Addendum to Request for Proposals for Cleaning Services - 2019

October 29, 2019

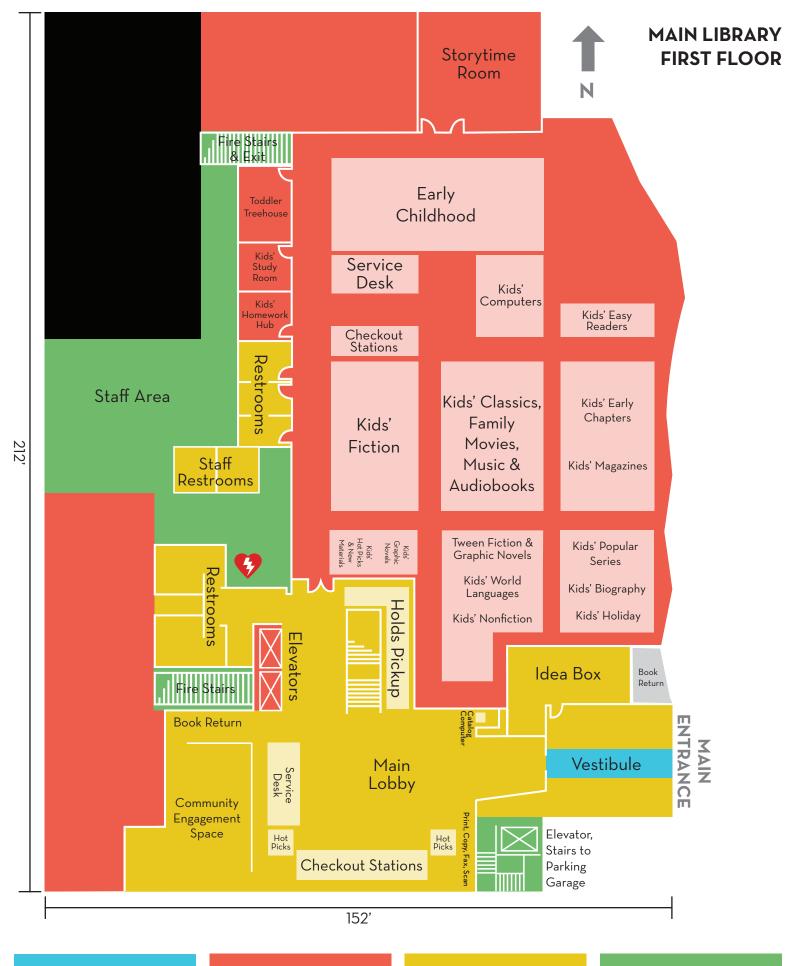
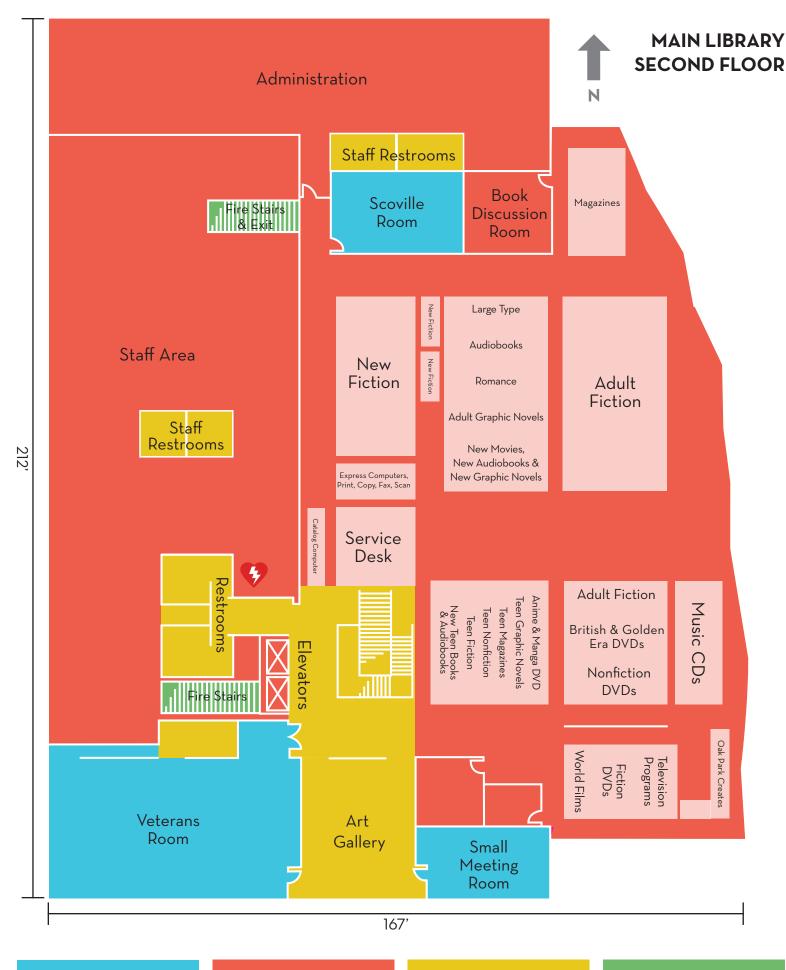
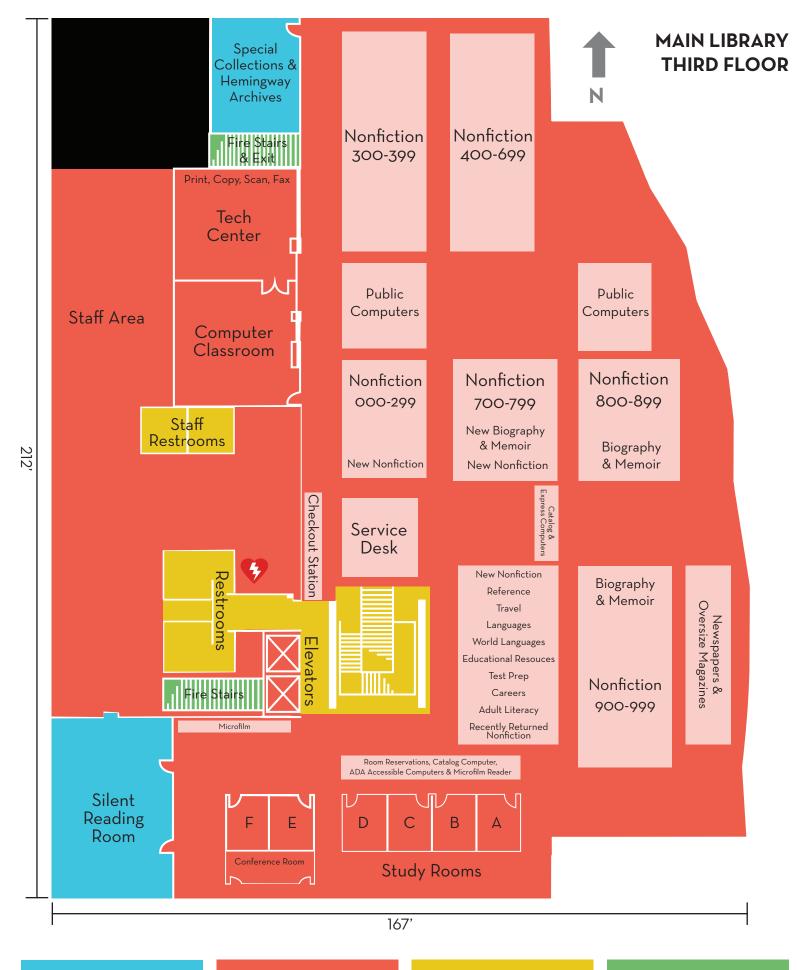
2. Does OPPL have a floor plan detailing square footage, floor type, restrooms, restroom fixtures?

See below for maps with flooring type for the Main Branch Library which has approximately 3800 square feet of carpeting. Note the flooring maps are not precise. These are for general location and size only.

We do not have maps of the Dole Branch Library, and Maze Branch Library floor plans are included below. Approximately half of the square footage noted on page 3 of the RFP is carpeted at Dole and Maze branches. Approximately half of the flooring at these locations is vinyl (or similar) commercial tile.
